# Western Transfer Interface Definition Change

Christopher Callaghan  
Sr. Engineer- Markets Coordination Department  
System Operations Subcommittee  
September 06, 2018

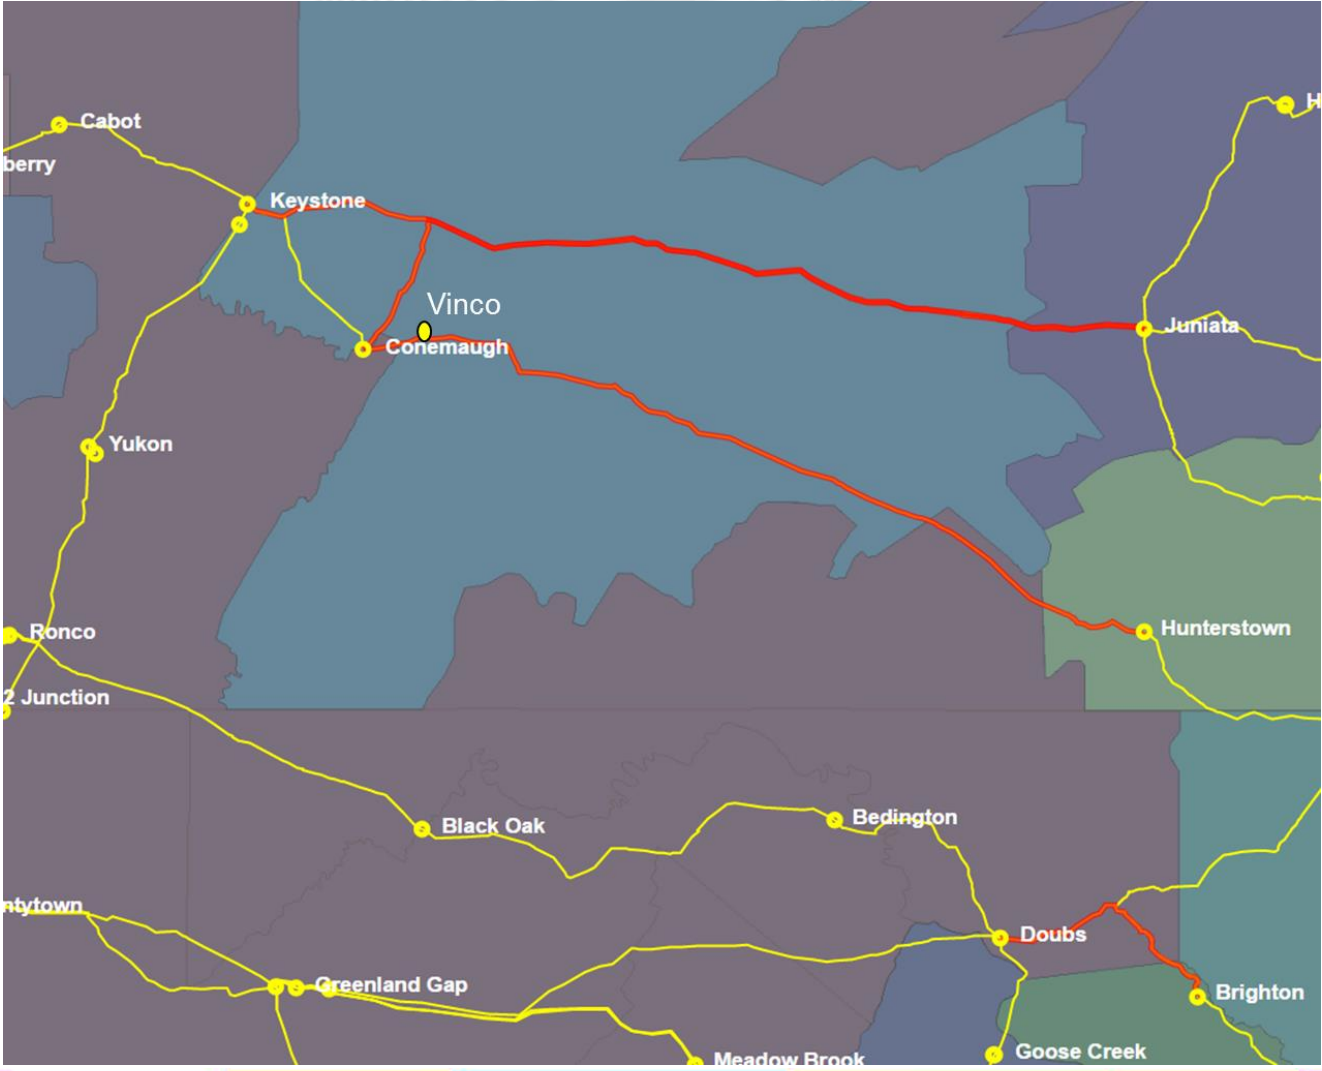
- Definition change is due to Network project n4682.
  - Adds new Vinco substation between Conemaugh and Hunterstown.
  - Definition will be effective when the new substation is energized (est. 10/16/18).

- Current Definition (from-to)
  - 5004 Keystone – Juniata 500 kV line
  - 5005 Conemaugh – Juniata 500 kV line
  - 5006 Conemaugh – Hunterstown 500 kV line
  - 5055 / 522 Doubs – Brighton 500 kV line
- New Definition (from-to)
  - 5004 Keystone – Juniata 500 kV line
  - 5005 Conemaugh – Juniata 500 kV line
  - 5068 Vinco – Hunterstown 500 kV line
  - 5055 / 522 Doubs – Brighton 500 kV line
